**SPRINGS AT WATERVIEW - AMENDED STORM**

GRINNELL DITCH NORTH - PLAN / PROFILE

GRINNELL DITCH SOUTH PROFILE

**STORM B PROFILE**

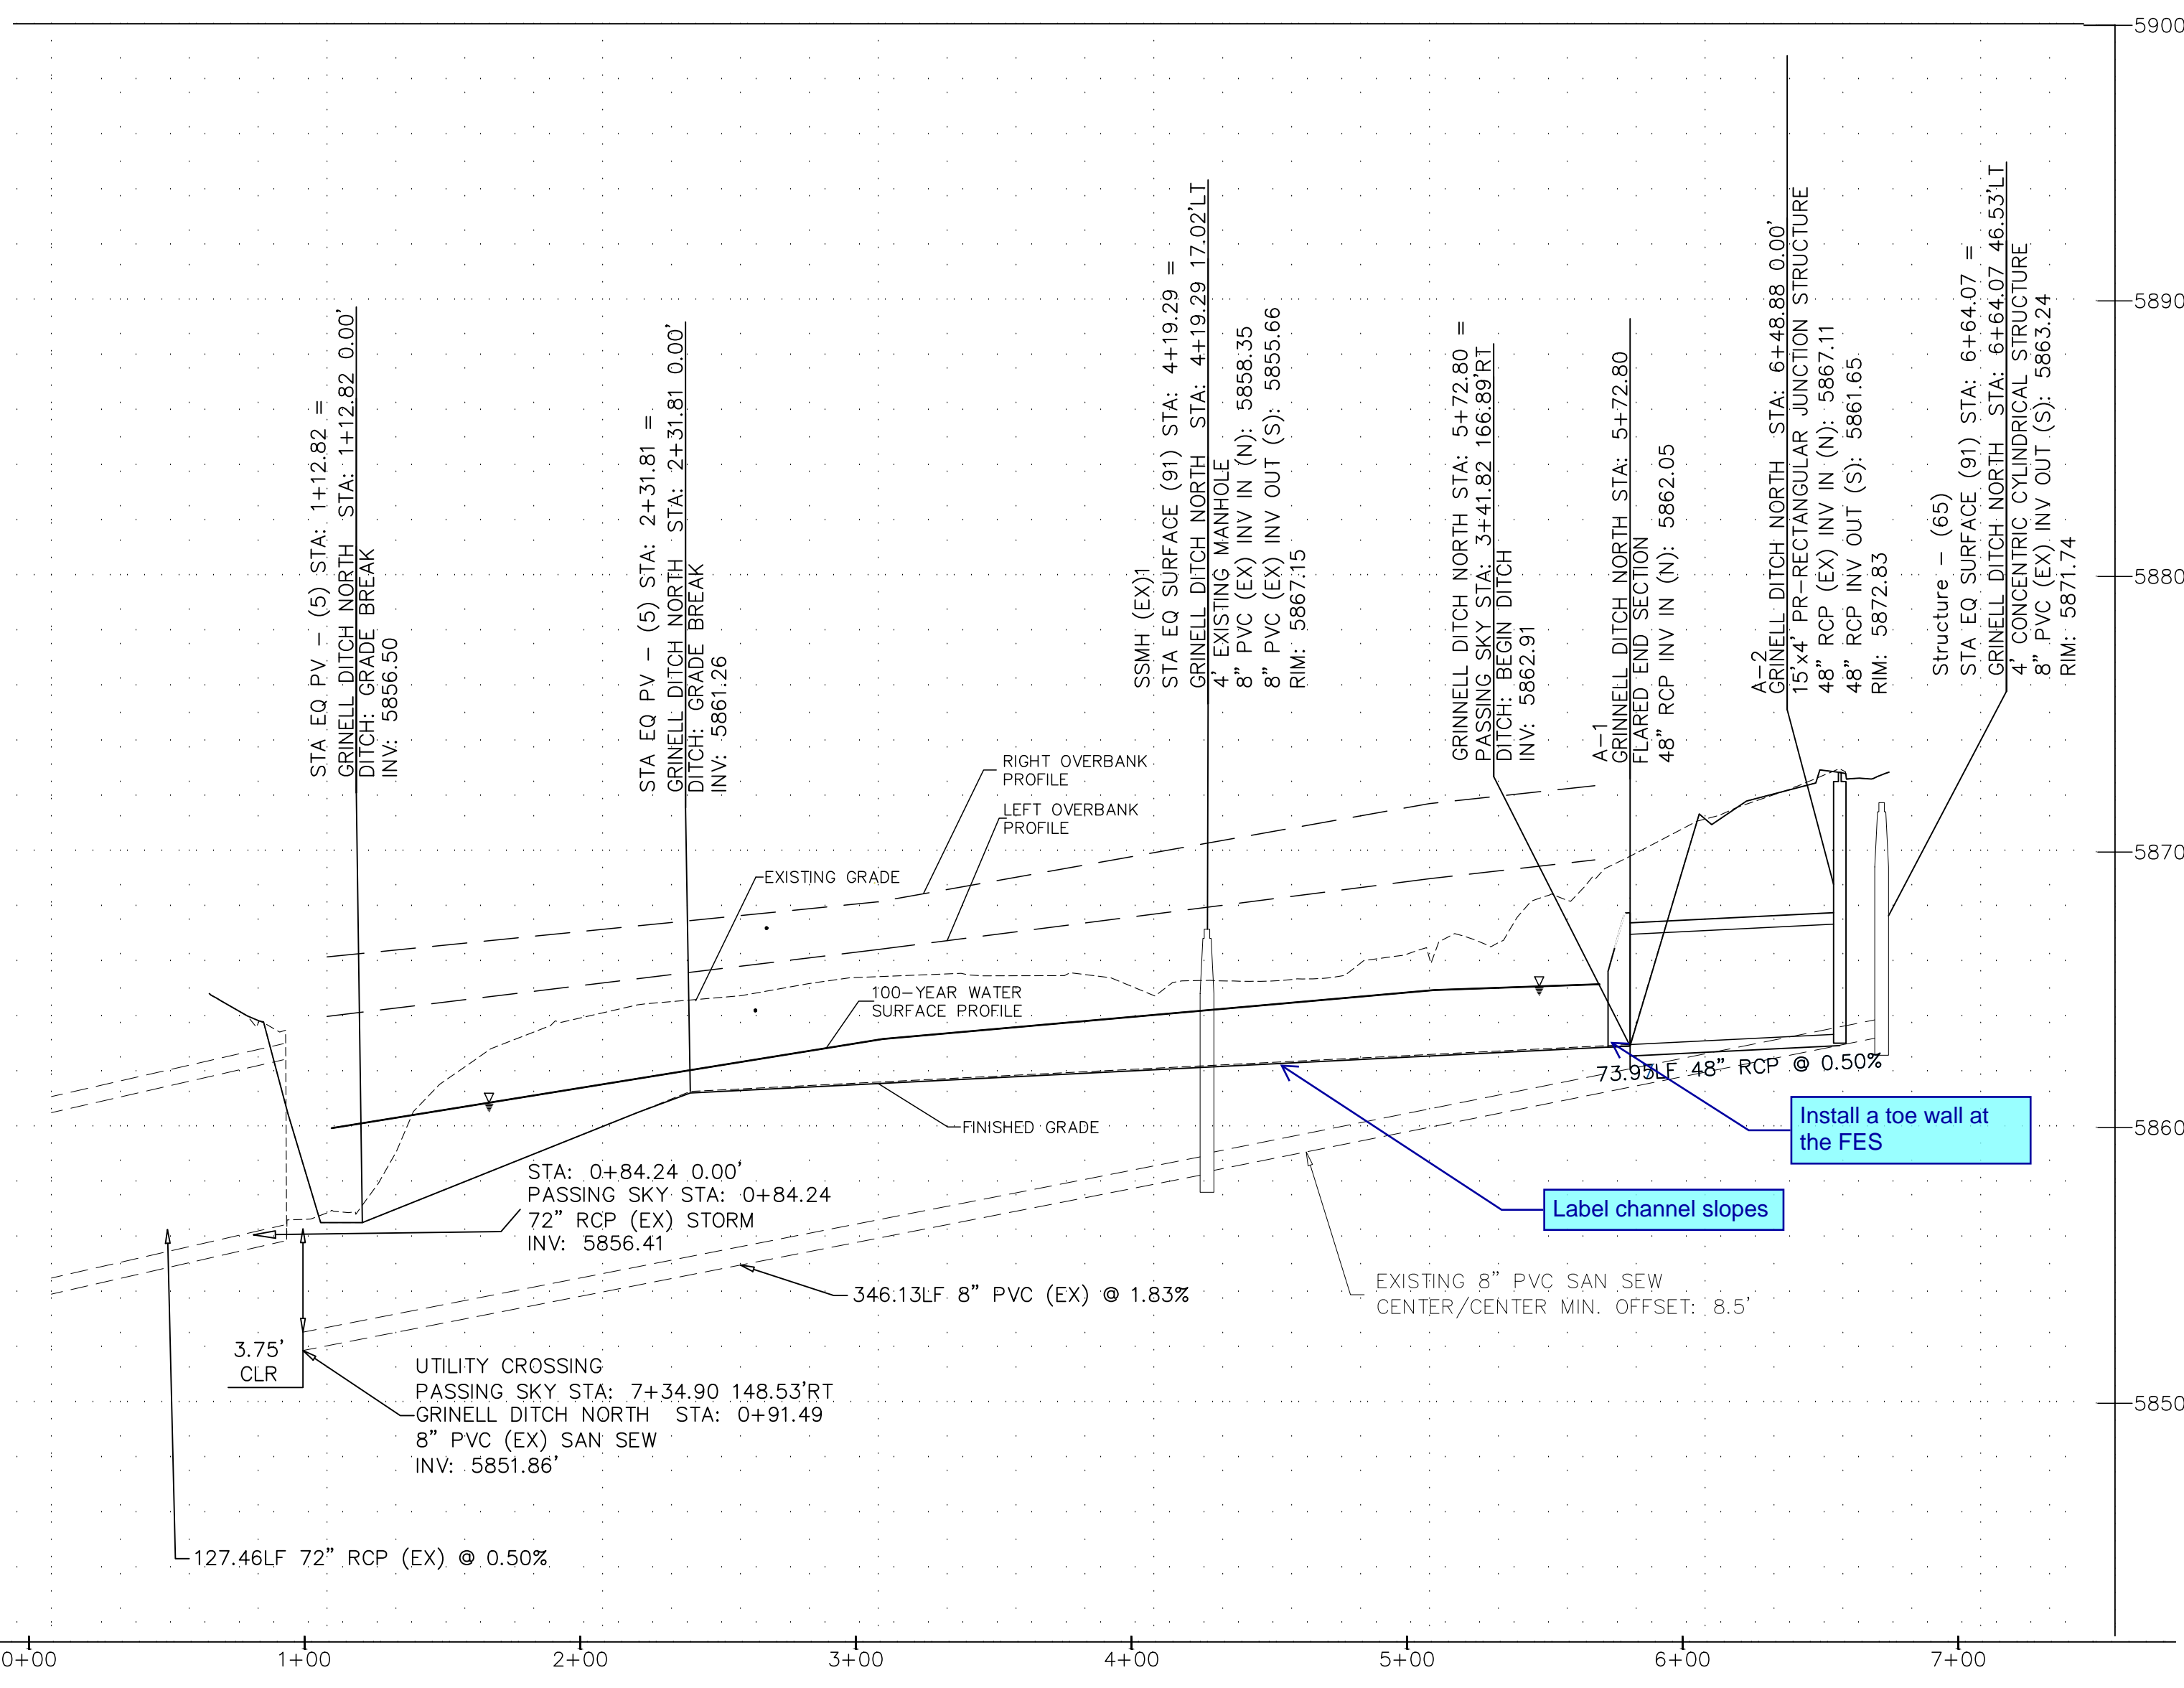
Provide riprap details. Identify the riprap type, length, width, depth. Is there a lining between the riprap and subgrade?

The property line is located in the middle of the channel. The

Is this supposed to be the edge of asphalt. Plat only shows a property line.

Drainage easement on the plat was only 25 feet. It should be adjusted to include the entire channel side.

Install a toe wall at the FES

Label channel slopes

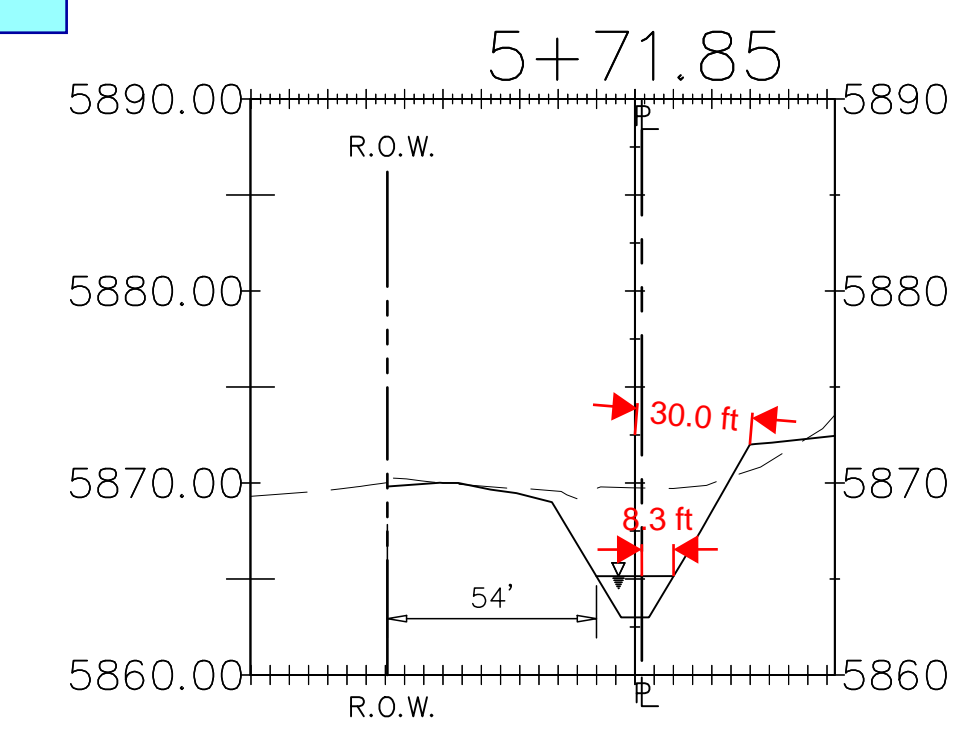
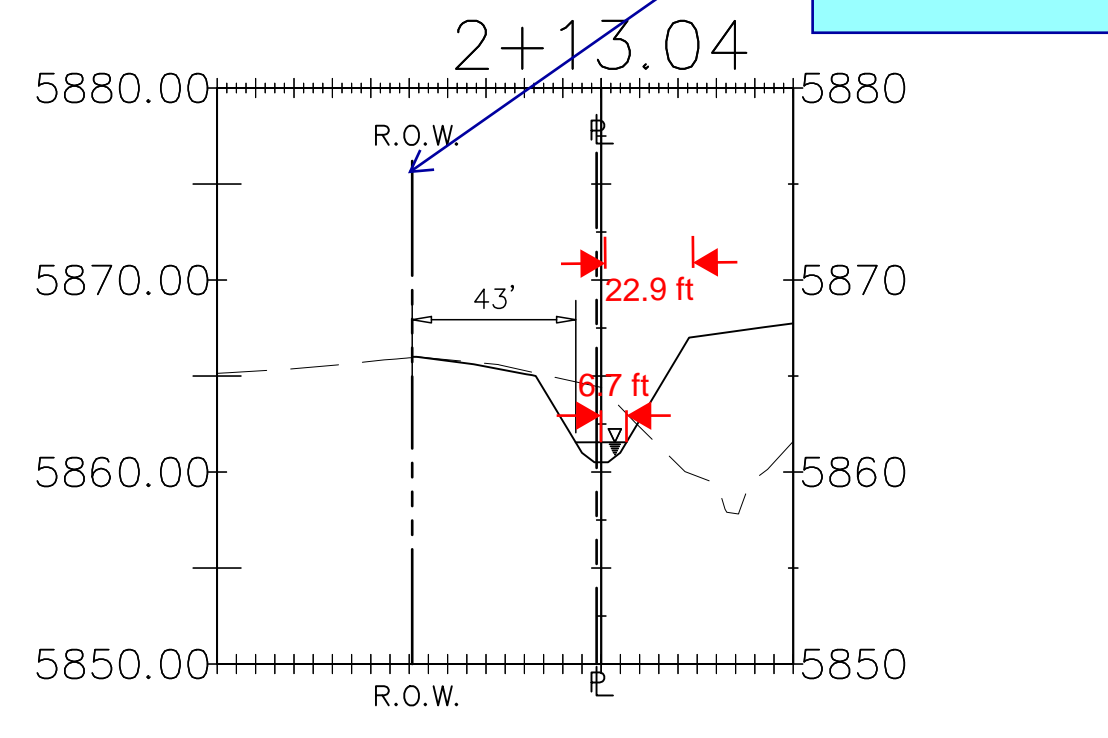
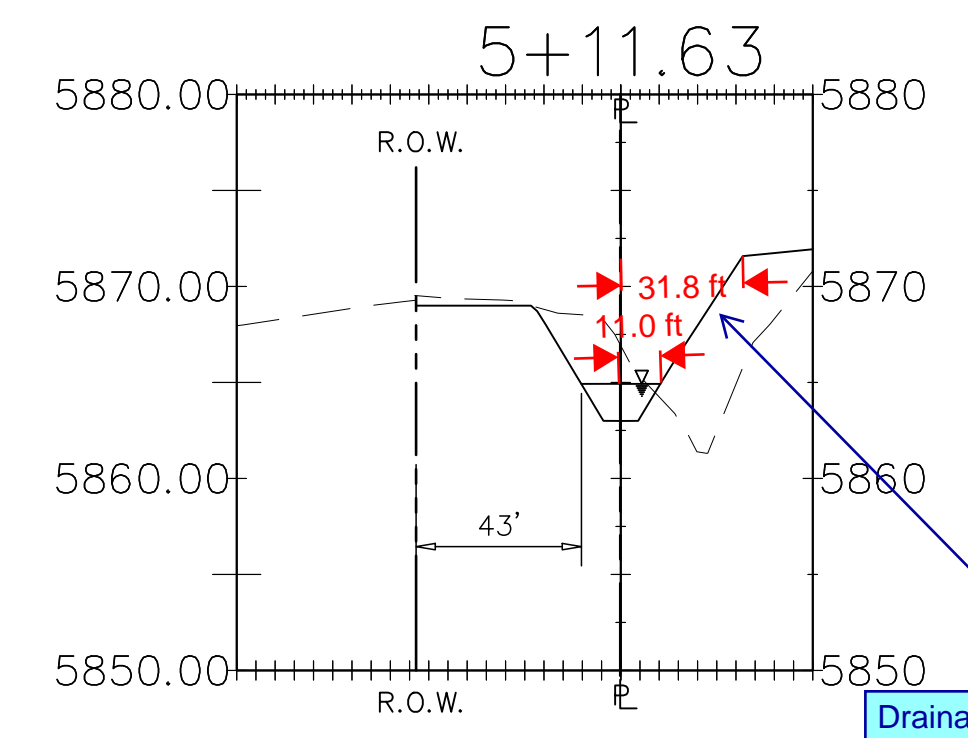
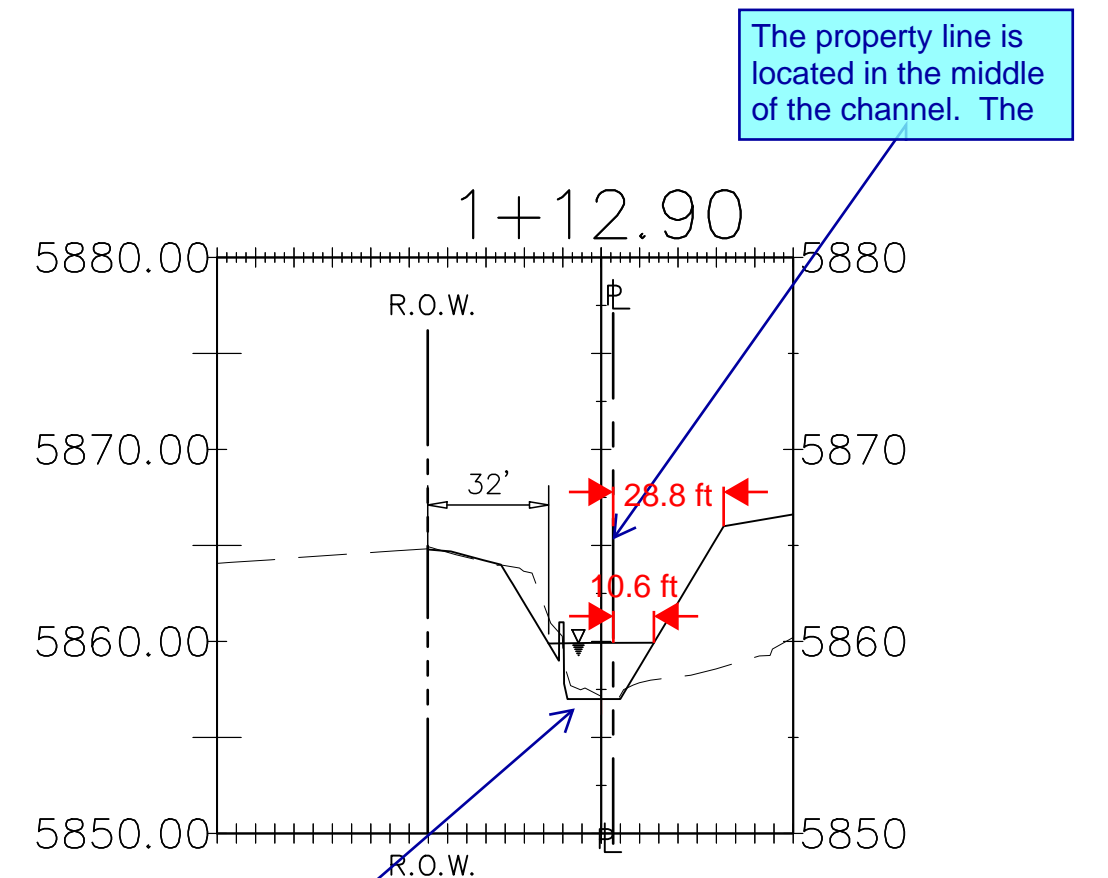
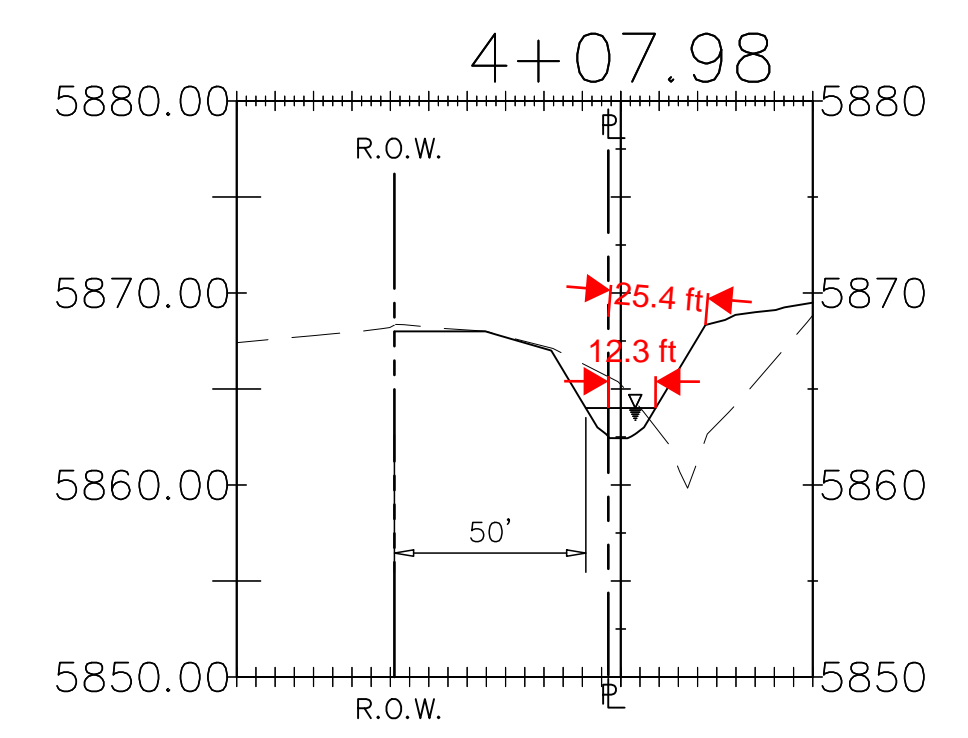
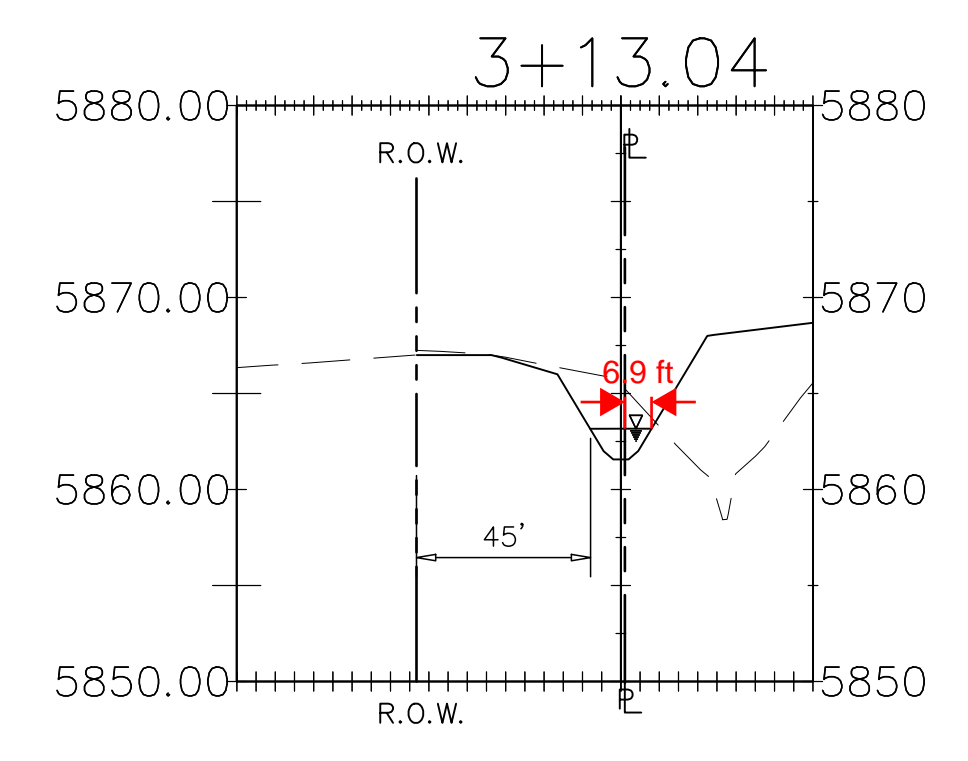
For all cross sections:  
- Label the station offsets of the toes.  
- Channel bottom width appears to vary  
- Label the existing and proposed grades.
